**From:** Donna Oldford <[dboldford@aol.com](mailto:dboldford@aol.com)>  
**Sent:** Sunday, December 16, 2018 9:26 PM  
**To:** Hade, Jason <[Jason.Hade@countyofnapa.org](mailto:Jason.Hade@countyofnapa.org)>; [Jake.Freedman@dot.ca.gov](mailto:Jake.Freedman@dot.ca.gov)  
**Cc:** [pjbergman@mac.com](mailto:pjbergman@mac.com); [mike@appliedcivil.com](mailto:mike@appliedcivil.com)  
**Subject:** Bergman Winery Hearing - Response to Caltrans Comments

**RE:** **BERGMAN WINERY ACCESS TO SR 29 – DOES DESIGN MEET CALTRANS HIGHWAY DESIGN MANUAL CRITERIA?**

**From:** Allen, Garrett@Wildlife <Garrett.Allen@wildlife.ca.gov>  
**Sent:** Thursday, December 13, 2018 10:29 AM  
**To:** Hade, Jason  
**Subject:** CDFW's Informal Comments on the Bergman Family Winery Mitigated Negative Declaration (SCH#2018112043)

**Figure 1**  
**Grist Mill State Park and Bergman Family Winery**  
**SR29 Access Intersection Geometrics in Relation to**  
**Caltrans Highway Design Manual Criteria**

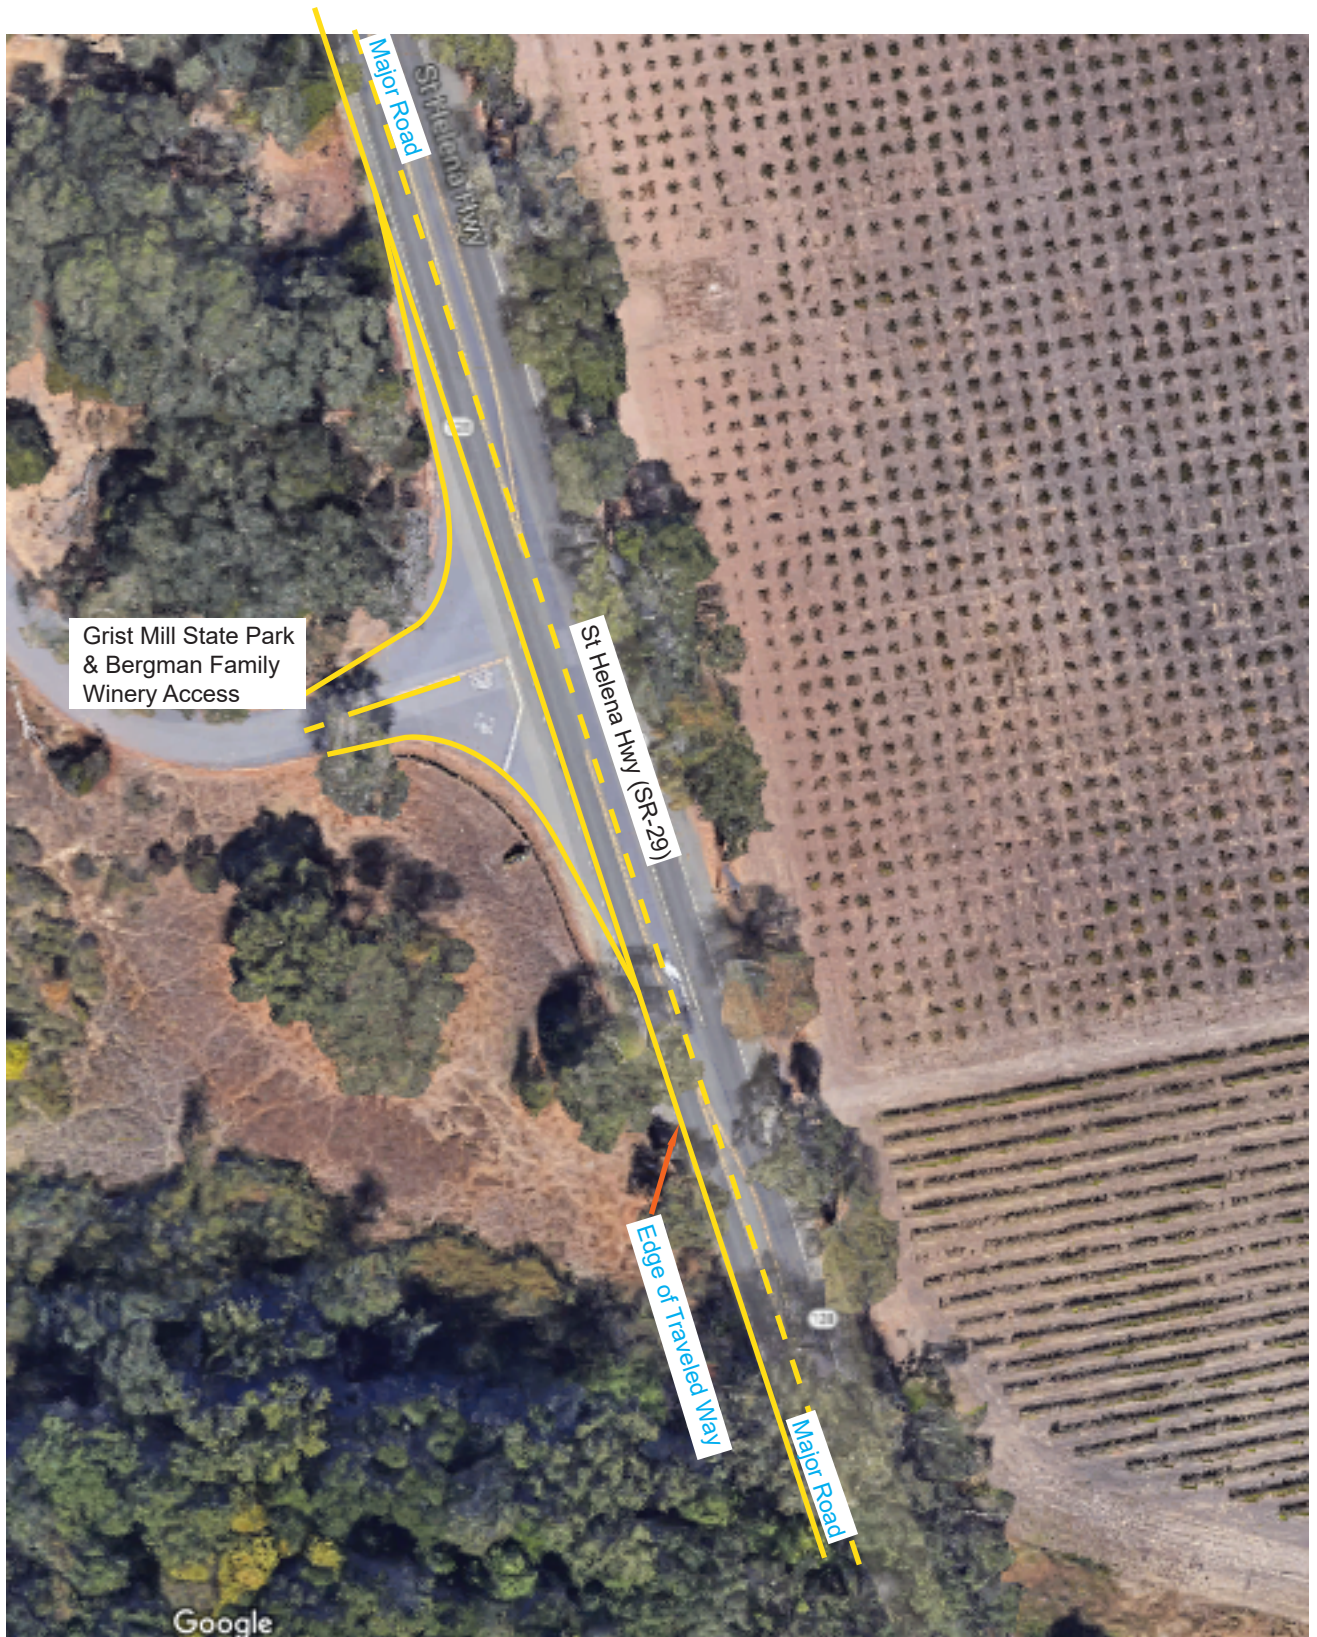
At your request Crane Transportation Group has evaluated whether the Bergman Winery access to SR 29 north of the City of St. Helena in Napa County meets Caltrans Highway Design Manual criteria. The Bergman driveway connects to the Grist Mill State Park access road (on the west side of SR 29) which then provides a connection to the state highway. The state park connection to SR 29 is shown on the attached **Figure 1**. Also shown is a template from **Figure 405-7** in the latest Caltrans Highway Design Manual (December 2018) for public road intersections superimposed on the air photo. As shown, the right turn in and out pavement design at the state park driveway connection meets current design criteria. It should also be noted that a left turn has been provided on the northbound SR 29 intersection approach.
